Technical Bulletin #10-3250401081

10-325 14" Deluxe Bandsaw

Subject: Table Leveling Screw Change

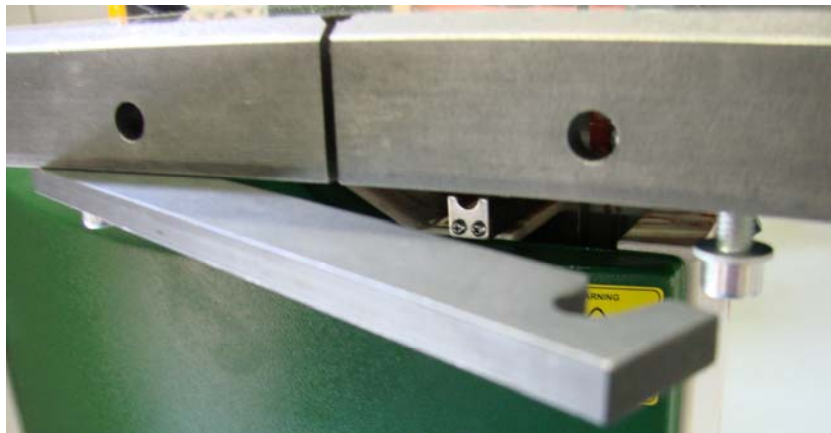
RIKON has improved the 10-325 14" Deluxe Bandsaw. RIKON omitted the table leveling screw and upgraded it with a steel bar to improve the support on the right side of the blade.

The new support bar is preinstalled on the table. The bar must be removed or in the opened position in order to install the table to the trunnion.
